STAFF REPORT
COMMUNITY DEVELOPMENT DEPARTMENT

HEARING DATE: 12/6/2022
 TO: Mayor & City Council
 FROM: Joe Dodson, Associate Planner
 208-884-5533
 SUBJECT: H-2022-0059
 Alden Ridge Subdivision
 LOCATION: 6870 N. Pollard Lane and the three (3) parcels to the north and east, directly east of SH 16 and directly south of the Phyllis Canal at the northern edge of the Meridian area of City impact, in the NE 1/4 of the SW 1/4 of Section 21, Township 4N, Range 1W.

Request for Annexation and Zoning of approximately 24.8 acres of land with a request for the R-4 (20.35 acres) and R-8 (4.45 acres) zoning districts and a Preliminary Plat consisting of 65 building lots and 10 common lots on approximately 21.7 acres of land in the requested zoning districts, by Dave Yorgason, Tall Timber Consulting.

REZONE - R4
 LYING WITHIN THE SW 1/4 OF SECTION 21, T.4N., R.1W., B.M.
 COUNTY OF ADA — STATE OF IDAHO

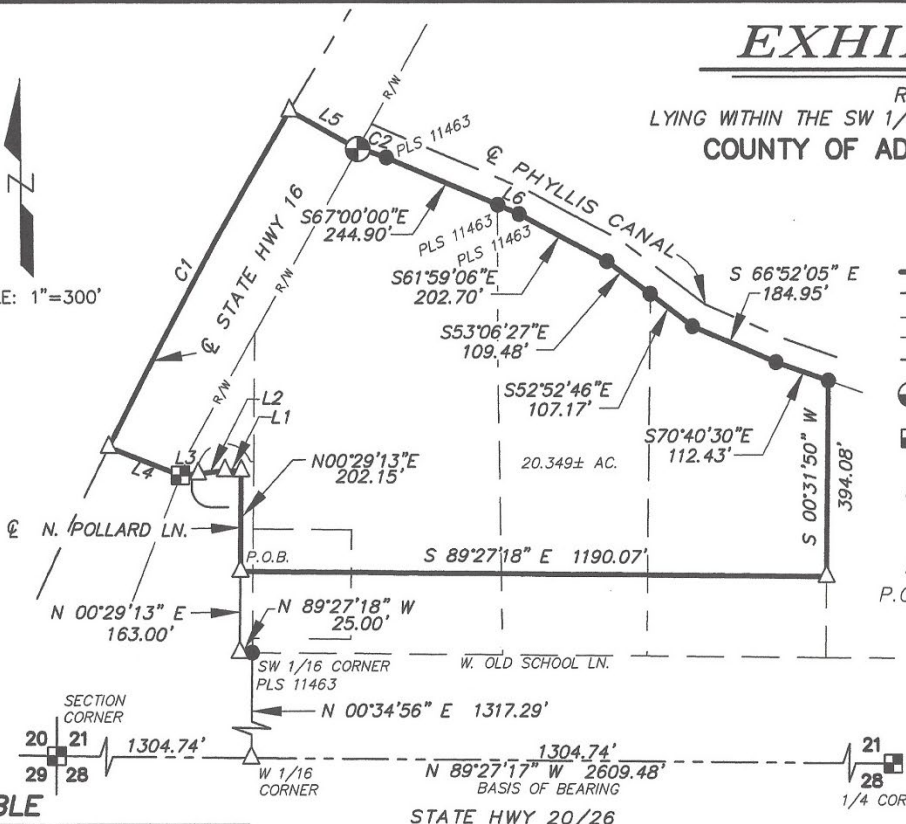
13. Prior to the City Council hearing, submit conceptual building elevations for the R-8 building lots.
14. The submitted R-4 & R-8 zoning legal descriptions and exhibit maps are mislabeled as Rezone exhibits; prior to the City Council hearing, the applicant shall provide revised legal descriptions and exhibit maps noting these to be "Zoning" instead of "Rezone."

C. Landscape Plans (date: 7/18/2022)

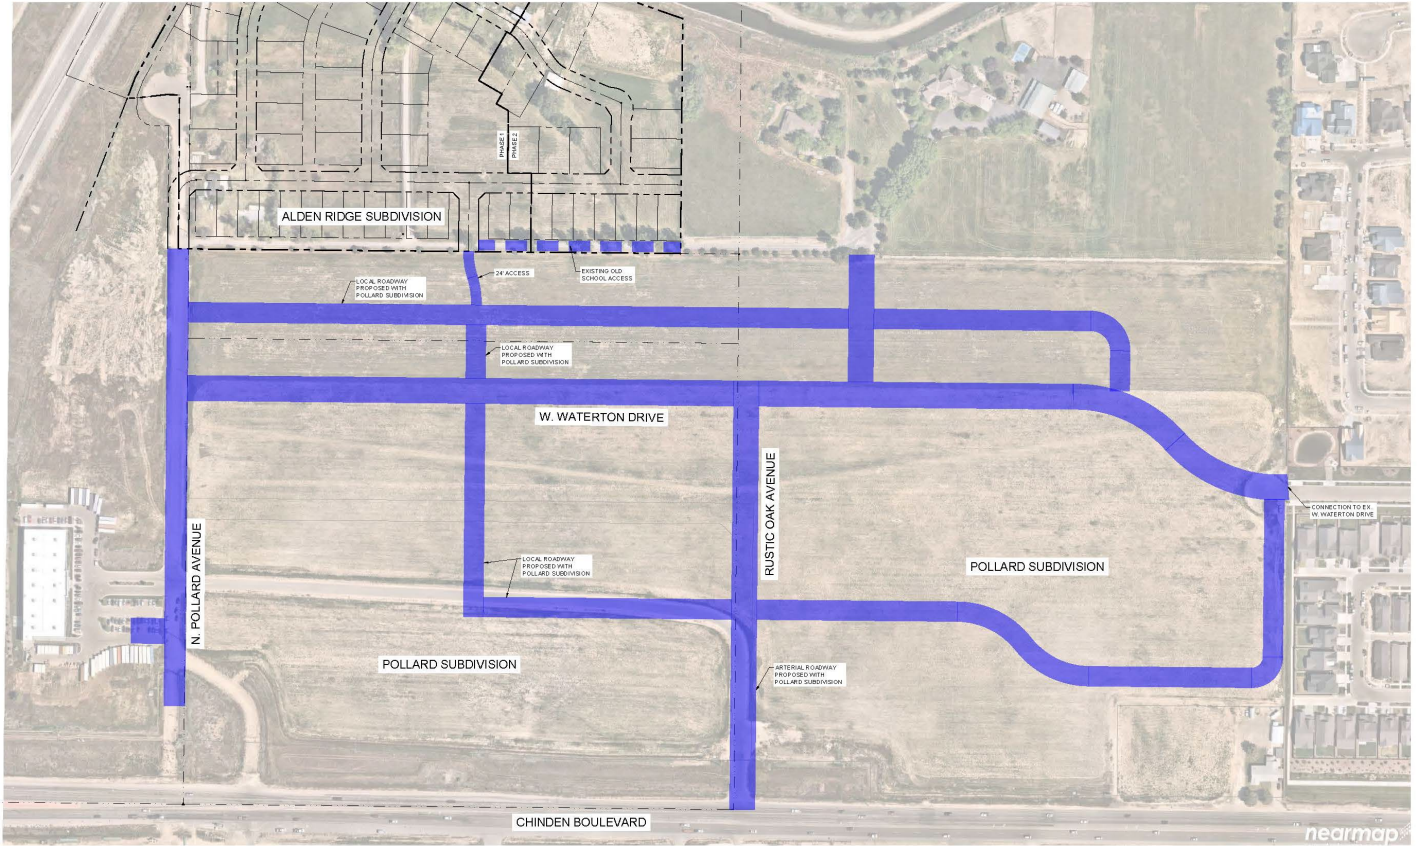
As discussed, the Applicant has proposed linear open space and micro-paths around and through the development. These areas should be landscaped in accord with UDC 11-3B-12 with trees at least every 100 linear feet and include other vegetative ground cover. According to the submitted landscape plans, the Applicant is proposing trees in excess of code requirements with sod throughout; additional vegetative ground cover is required in accord with UDC 11-3B-12. The Applicant should revise the landscape plans to depict the required revisions with the relevant final plat applications.

According to the submitted landscape plans, the Applicant is proposing two types of fencing throughout the site, vinyl privacy fencing and vinyl semi-privacy fencing, in addition to proposing a masonry wall at the top of the berm along the west boundary adjacent to SH 16. Staff finds the locations of all of the proposed fencing to comply with UDC requirements. However, the type of semi-private vinyl fencing shown within the submitted landscape plans do not comply with the exhibits depicted with the UDC that requires the solid portion to be no more than 4 feet in height and the top 2 feet must be at least 80% open-vision. The Applicant is required to revise this type of fencing shown on the submitted plans with future final plat applications.

In addition, the Applicant is proposing a berm/wall combination along the SH 16 frontage at the northwest property boundary and notes the wall to be approximately 4 feet in height with a 4-foot to 5-foot tall berm; therefore, the combined height of the berm/wall is approximately 8-9 feet in height. UDC 11-3H-4, development along state highways, is applicable in this area of the project because of the frontage with SH 16. Code requires the berm/wall combination to be a minimum of 10 feet above the centerline of the highway. Therefore, the applicant should revise the height of the proposed berm and wall to comply with the UDC.

3. The landscape plan included in Section VII.C, dated July 18, 2022, shall be revised as follows prior to submitting for Final Plat approval:
 - a. Depict additional vegetative ground cover in all linear open space consistent with UDC 11-3B-12.

- b. Revise the design of the semi-private open vision fencing proposed to be consistent with Figure 1 in UDC 11-3A-7.
 - c. Per UDC 11-3H-4, revise the height of the berm/wall combination to be at least 10 feet above the centerline of SH 16 and depict this height within the exhibit on the Landscape Plans.
